TECHNICAL EXHIBIT #4

HANGAR 32 ELECTRICAL INSPECTION - MCKINSTRY CO

PROJECT: HANGAR 32 ELECTRICAL PLANS

PROJECT #: WRC-G-22-01
DATE: 12/20/23
DRAWN BY: JV
SHEET NO: E6.01

1 ED600 HANGAR 32 SINGLE-LINE DIAGRAM - POWER
SCALE: NONE

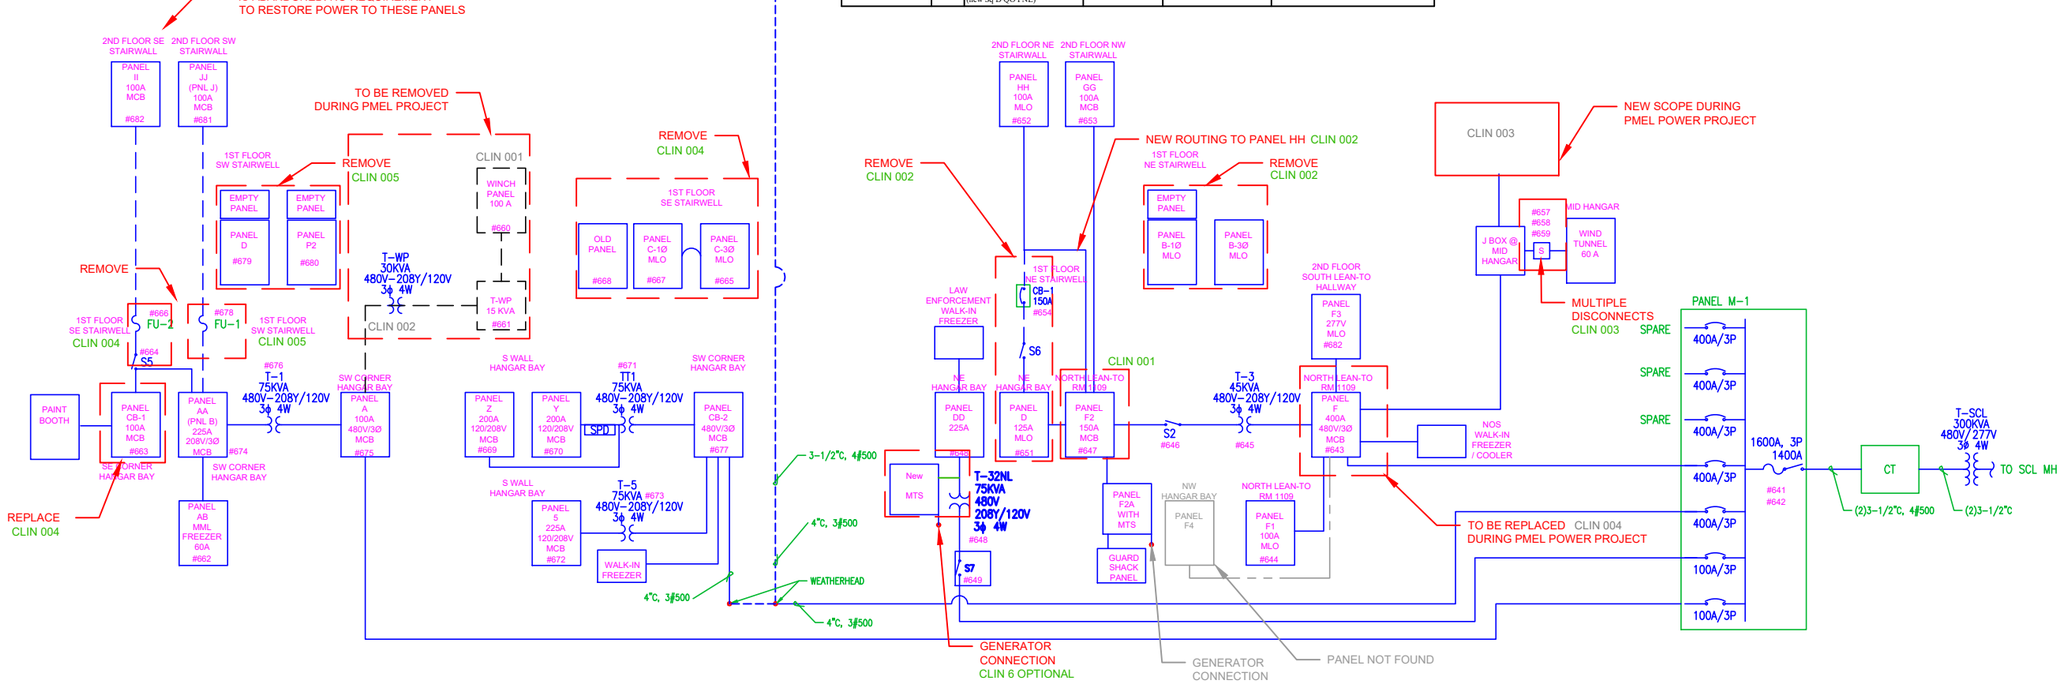
LOCATION	"ID TAG #"	EQUIPMENT DESCRIPTION	RECOMMENDED ACTION	McK REMARKS	NOAA REMARKS FOR ADDITIONAL CLIN WORK
Bldg. 32 NW Corner/Room 112	641	Switchboard 800A Fused – 480V 3PH, 4W	NONE		
Bldg. 32 NW Corner/Room 112	642	Switchboard 800A Fused – 480V, 3PH, 4W	NONE		
Bldg. 32 NW Corner/Room 109	643	PNL-F 400A Main Breaker,480V, 3PH, 4W	NONE	(5)K.O. Seals needed - Very Old, Remove/Replace	Replacing in PMEL Power Project
Bldg. 32 NW Corner/Room 109	644	PNL-F1 Main Lug 100A, 480V, 3PH, 4W	NONE		
Bldg. 32 NW Corner/Room 109	645	45 KVA Transformer 480V?208V	NONE		
Bldg. 32 NW Corner/Room 109	646	Disconnect S-2 , 150A, 208V, 3PH Feeds PNL-F2	NONE	Very Old, Remove/Replace	Remove
Bldg. 32 NW Corner/Room 109	647	PNL-F2 150A Main Breaker, 208V, 3PH, 4W	NONE	"K.O. seals needed, 3",1",3/4", ½" CKT-26,28,30 has 2wires per, wrong size wire for 100A 3-pole"	Repair
Bldg. 32 - NE Corner	648	"PNL-DD Main Lug 120/208V, 3PH, 4W Fed from 75KVA Transformer"	NONE	Panel does not have main breaker or disconnecting means. Needs ½" K.O. seal	Repair as part of new MTS for generator connection

Bldg. 32 - NE Corner	649	Disconnect T-32NL 100A 480V, 3PH, 3W	NONE	"Disconnect is not fused, missing bushing on line side, missing mounting screws to hold to wall. Fed from?"	Repair as part of new MTS for generator connection
Bldg. 32 - NE Corner	650	75 KVA Transformer	NONE		
Bldg. 32 - NE Corner	651	PNL-D 125A 120/208V, 3PH, 4W	NONE	Main lugs used to splice #2 and #6 STR copper conductors. Fed from?	Remove
Bldg. 32 - NE Stair – 2nd Floor	652	PNL-HH 100A 120/208V 3W	Low Grade Fault	"CKT-18 To be monitored – Plan new inspection within 90 days Dan Krigsvold removed hot breaker(#18), Re-terminated wire to ckt-20"	Review for repair
Bldg. 32 - NE Stair – 2nd Floor	653	PNL-GG 100A 120/208V 3W	NONE		
Bldg. 32 - NE Stair – 2nd Floor	654	150A Breaker Feeds Security Fed from Panel D (splice box)	NONE	Very old – Plexiglass cover Remove/Replace - Wrong size wire	Remove
Bldg. 32 – Center - West	655	PNL-K 225A 3PH, 4W	NONE	Old – Remove/Replace Many code violations	Removed in BiB Demo

Bldg. 32 – Center - West	656	75 KVA Transformer T-2 480V?208V	NONE		Removed in BiB Demo
Bldg. 32 – South of Center	657	60A Disconnect 480V, 3PH (Rope Strength Tester)	NONE	"Code Violations – wire size too small (2)#10 wires on each lug of load side"	Repair
Bldg. 32 – South of Center	658	Disconnect 60A 480V, 3PH	NONE	"Code Violations-#12AWG Doubled up w/#6AWG on Line side lugs. Remove/Replace"	Repair
Bldg. 32 – South of Center	659	Disconnect 30A 480V, 3PH	NONE	Code Violations- 250V fuses, Remove/Replace – Very old	Repair
Bldg. 32 – South of Center – West wall	660	"100A PNL, 120/208V, 3PH, 4W (new Sq D PNL fed from 30KVA XFMR)"	NONE		
Bldg. 32 – South of Center – West wall	661	30 KVA Transformer 480V?120/208V	NONE		
Bldg. 32 - SE (Brown Structure)	662	"PNL- AB 125A 120/208V 3PH, 4W, Main Lug (new Sq D QO PNL)"	NONE	Code Violation- needs correct lug (#4-#14AWG) for ground.	Repair

LOCATION	"ID TAG #"	EQUIPMENT DESCRIPTION	RECOMMENDED ACTION	McK REMARKS	NOAA REMARKS FOR ADDITIONAL CLIN WORK
Bldg. 32 - SE	663	PNL-CB1 100A, 208V, 4W, Main Breaker	NONE		Relocate for proper access
Bldg. 32 - SE	664	Disconnect S-5 125A Fused, 208V, 3PH,	NONE	"Code Violation-Line side lugs not rated for (2)#2AWG, Load side not rated for #6 and #2AWG- Very old – Remove/Replace"	Remove / Replace if needed
Bldg. 32 – SE Stair Room 132C	665	PNL-C 3PH, Sub to P2	NONE	Very old, Remove/Replace	Remove - unclear if this has lighting circuits
Bldg. 32 – SE Stair Room 132C	666	FU-2 (2)100A Fuses 208V	NONE	Very old, Remove/Replace	Remove
Bldg.32	667	Light Panel C Single Phase Bottom Right	NONE	Very old, Remove/De-Energized	Remove - unclear if this has lighting circuits
Bldg.32	668	Panel Top Right (8)Glass Fuses 120/208V	NONE	Very old, Remove/Replace	Remove
Bldg.32	669	PNL-Z 200A, 120/208V, 3PH, 4W, Main Breaker	NONE

Bldg.32	670	PNL-Y 200A, 120/208V, 3PH, 4W, Main Breaker	NONE		
Bldg.	671	75 KVA Transformer TT1	NONE		
Bldg.32	672	PNL#5 225A, 120/208V	NONE		
Bldg.32	673	75 KVA Transformer #5 480?208V	NONE		
Bldg.32 - South Wall - West	674	"PNL-AA 225A, 120/208V, 3PH, 4W, Main Breaker"	NONE		
Bldg.32 - South Wall - West	675	PNL-A 100A 277/480V, 3PH, 4W, Main Breaker	NONE	"Code Violation- Line side main breaker (2)#4AWG on each lug"	Repair
Bldg.32 - South Wall - West	676	75 KVA Transformer T-1 480?208V	NONE	Top of transformer damaged	
Bldg.32 - South Wall - West	677	"PNL-CB2 400A, 277/480V, 3PH, 4W, Main Breaker"	NONE		
Bldg.32 SW Room 149D	678	PNL-FU-1 (2)150A Fuses 120/208V	NONE	Very old, Remove/Replace	Remove
Bldg.32 SW Room 149D	679	PNL-D	NONE	Very old - Remove – De-Energized	Remove
Bldg.32 SW Room 149D	680	PNL-P2	NONE	Very old - Remove – De-Energized	Remove
Bldg.32 - SW - Stair – 2nd floor	681	PNL-JJ 100A 1PH, 3W, 120/208V, Main Breaker	NONE	Splices in panel	Investigate for repair

Bldg.32-South-2nd floor-Hall/Center	682	PNL-F3 100A 277/480V, 3PH, 4W, Main Lugs	NONE	"Code Violation- 480V PNL w/ 120/208V colors(Blk,Rd,Blu)"	Change marking on panel to conform with code.
